PALO VERDE NUCLEAR GENERATING STATION UNITS 1, 2 & 3
DRAWING CHANGE NOTICE (DCN)
JOB NO. 10407

DRAWING NO.	SHEET NO.	REV.	DCN NO.
13-E-CHB-026		4	7

REASON FOR CHANGE: PER VENDOR CHANGE REQUEST (REF: C-E LETTER V-CE-15887, FEB. 1, 1982)

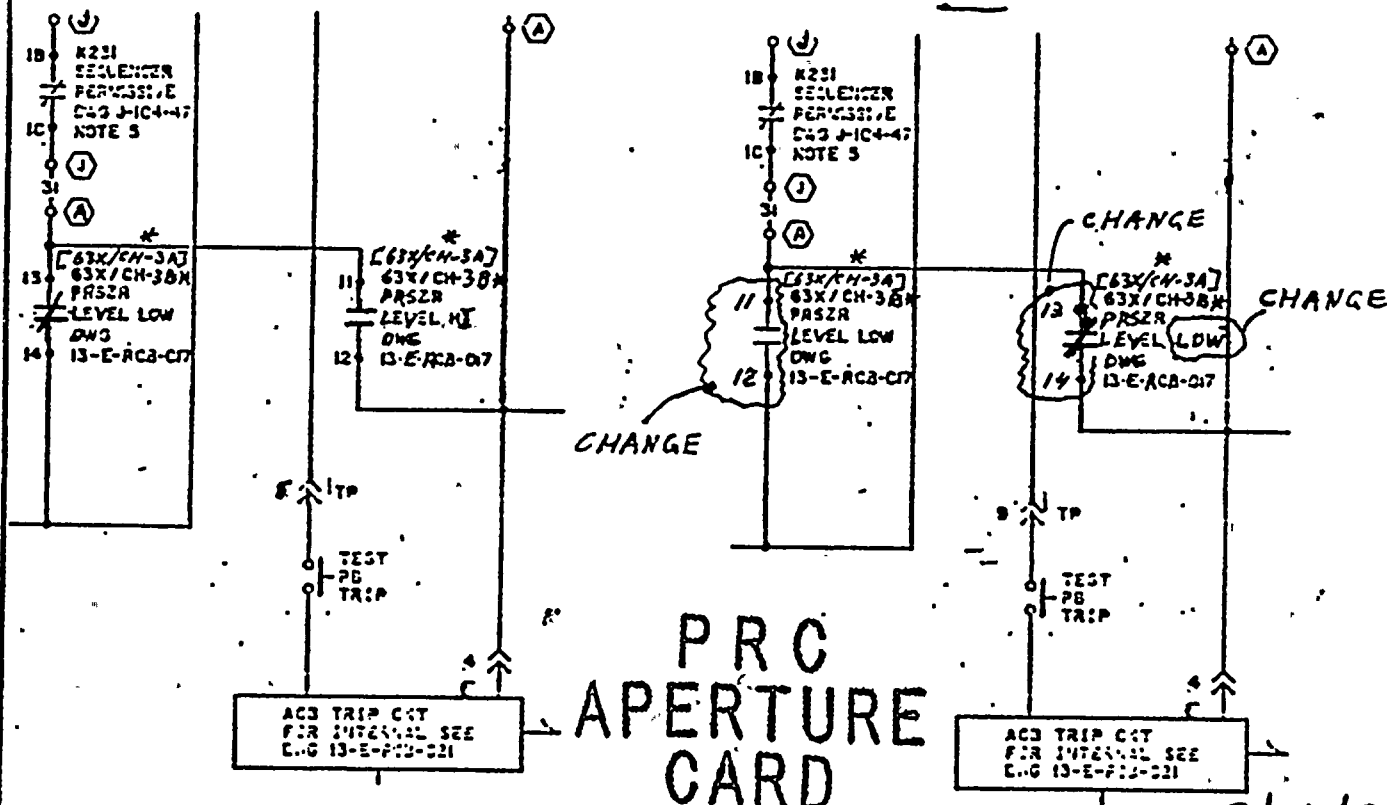
DESCRIPTION OF CHANGE AT LOCATIONS: F-5 & F-6 CHANGE DIAG-
RAM AS INDICATED BY:

REMARKS: NO ADDITIONAL CIRCUITS, EE-580 TERMINATIONS
NEED REWORK, SUSS-1CH04; T/O-09/02/81

DRAWING NO.	SHEET NO.	REV.	DCN NO.
13-E-CHB-025		4	7

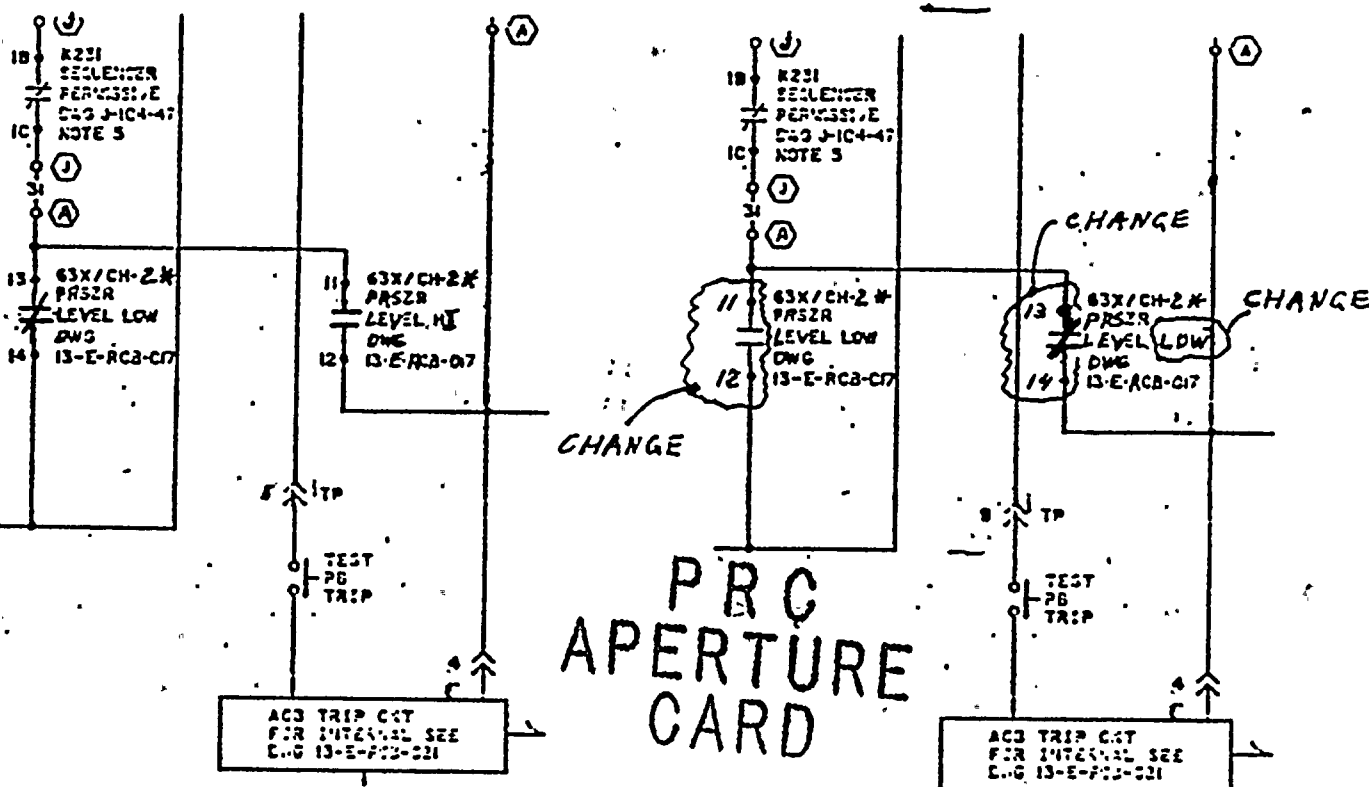
REASON FOR CHANGE: PER VENDOR CHANGE REQUEST (REF: C-E LETTER V-CE-15887, FEB. 1, 1982)

DESCRIPTION OF CHANGE AT LOCATIONS: F-5 & F-6 CHANGE DIAG-
RAM AS INDICATED BY:

REMARKS NO ADDITIONAL CIRCUITS, EE-580 TERMINATIONS

NEED REWORK, SUSS-1CH04; T/O - 09/02/81; DCP-15J-CH-088

DRAWING NO.	SHEET NO.	REV.	DCN NO.
13-E-CHB-024		4	6

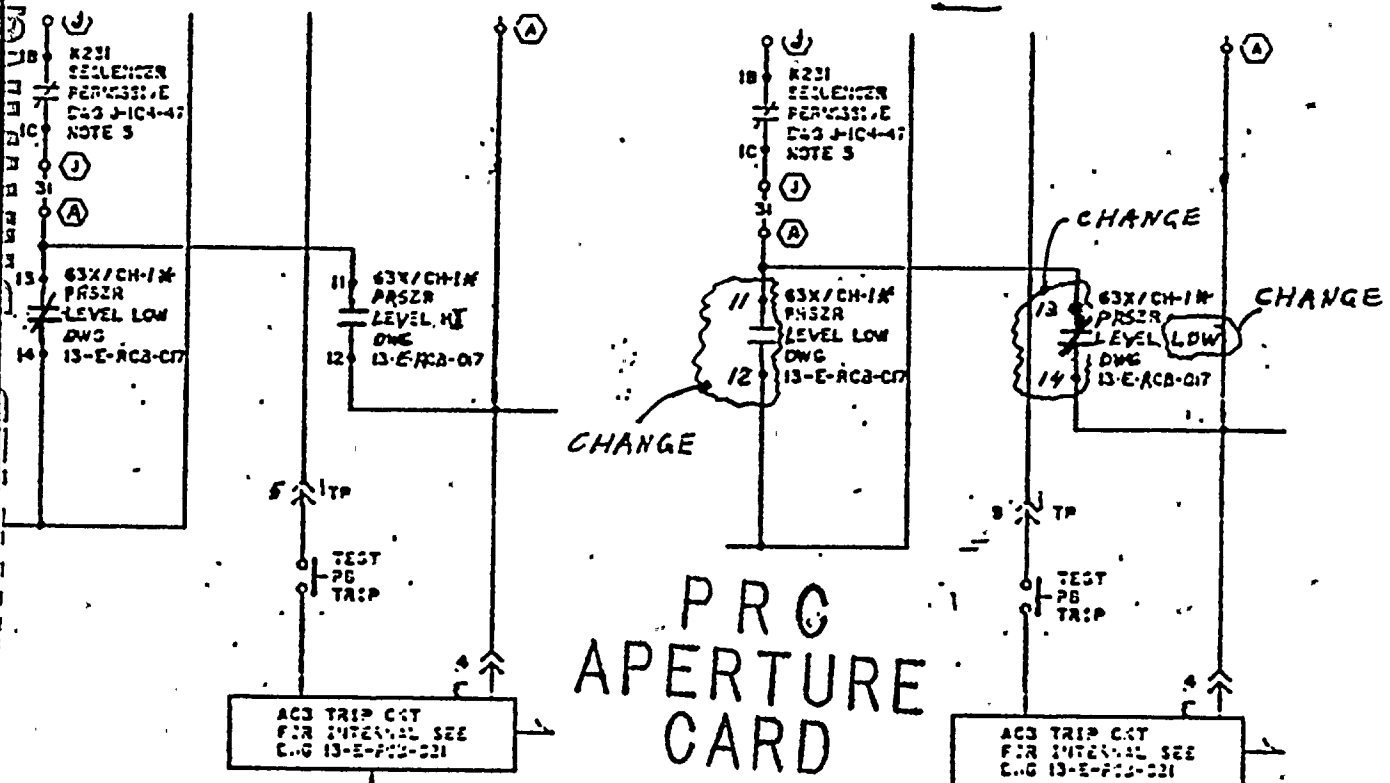
CHANGE REQUESTED BY: ☐ CLIENT ☒ ENGINEERING ☐ FIELD ☒ SUPPLIER/CONTRACTORREASON FOR CHANGE: PER VENDOR CHANGE REQUEST (REF: C-E LETTER
V-CE-15887, FEB. 1, 1982)DESCRIPTION OF CHANGE AT LOCATIONS: F-5 & F-6 CHANGE DIAG-
RAM AS INDICATED BY:

GROUP SUPERVISOR 2/24/82 N/A
PROJECT ENGINEER 2/24/82 N/A
REMARKS NO ADDITIONAL CIRCUITS; EE-580 TERMINATIONS

NEED REWORK. SUSS-1CH04; T/O-09/02/81; DCP-15J-CH-088
